California Independent System Operator

**Comments of the California Wind Energy Association and  
the American Wind Energy Association on the  
CAISO Issue Paper on Reactive Power Requirements and Financial  
Compensation**

June 11, 2015

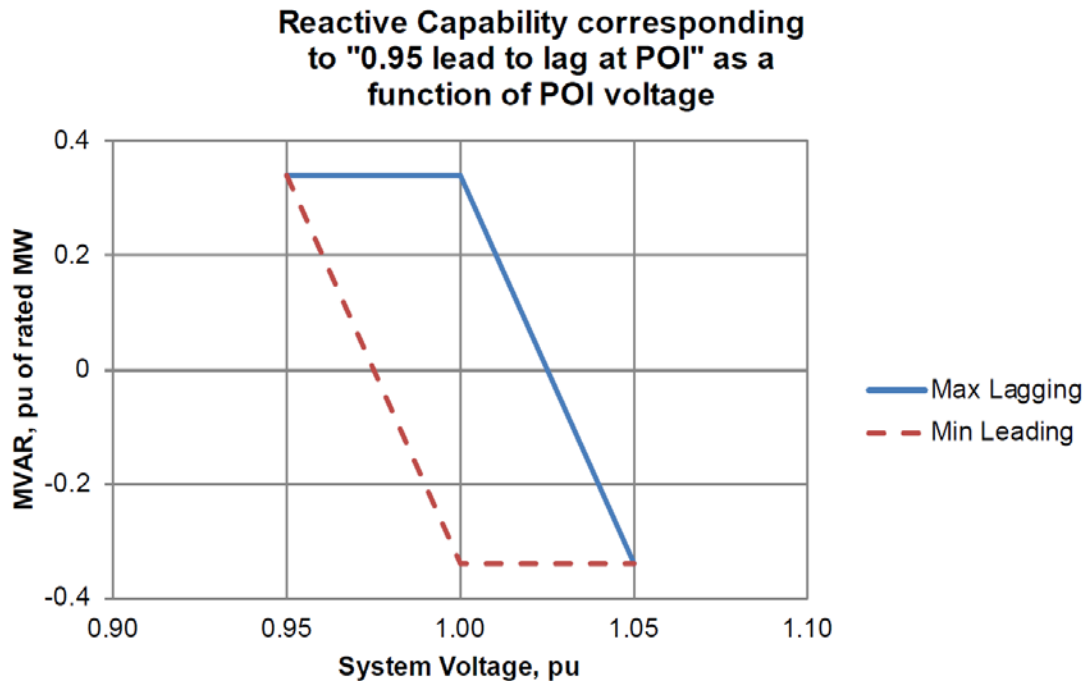
The descriptions of the reactive power requirement in the Issue Paper are conflicting and require clarification. Figure 6 accurately indicates that the magnitude of an asynchronous generator’s reactive power requirement will vary with the level of real power generation. However, there are a number of places in the paper that indicate that the asynchronous generator must provide its full reactive power requirement regardless of its level of real power generation.

This is inconsistent with Figure 6, which shows that the full reactive power requirement should apply only when the generator is at full rated real power). Examples of this inconsistency can be found at p.20 of the CAISO Issue Paper:

Furthermore, Figure 5 of the CAISO Issue Paper, which illustrates what the reactive power response should be as the voltage at the POI changes, incorrectly labels the Y-axis as MVARs per unit of “rated” capacity, rather than its power factor requirement.

The above statements and Figure 5 in the Issue Paper imply that, regardless of its level of real power generation, the asynchronous generator must provide its full reactive power requirement. In order to address this inconsistency in the paper, as well as to address another

- All specific statements regarding the magnitude of reactive power, such as the ones noted above, should be modified to make it clear that the magnitude of the reactive power requirement varies with the magnitude of real power generation. We suggest the following as examples for the CAISO's consideration:

"An Asynchronous Generating Facility shall have an over-excited (lagging) reactive power producing capability to achieve a net power factor from 0.95 lagging up to unity power factor at the Point of Interconnection, at the Generating Facility's maximum real power capability. However, the generator's maximum reactive power requirement would vary based on its level of real power generation as shown in Figure 6."

"An Asynchronous Generating Facility shall have an under-excited (leading) reactive power absorbing capability to achieve a net power factor from 0.95 leading up to unity power factor at the Point of Interconnection, at the Generating Facility's maximum real power capability. However, the generator's maximum reactive power requirement would vary based on its level of real power generation as shown in Figure 6."

In addition, Figure 5, which specifies the magnitude of the reactive power requirement from the asynchronous generator based on the POI voltage, should be modified to label the vertical coordinates as "Power Factor at POI" and the scale should range between 0.95 leading and 0.95 lagging. Alternatively, the vertical coordinate could be re-labeled as "MVARs per unit of actual real power generation."

- The description of Figure 5 should clearly state that voltage (the horizontal axis) corresponds to the voltage schedule at the point of voltage regulation (normally the POI).
- As we discussed during the stakeholder call of May 28, 2015, an asynchronous generator should be allowed to stop providing reactive power capability if its real power output falls below a certain real power level to be agreed to as part of the GIA.
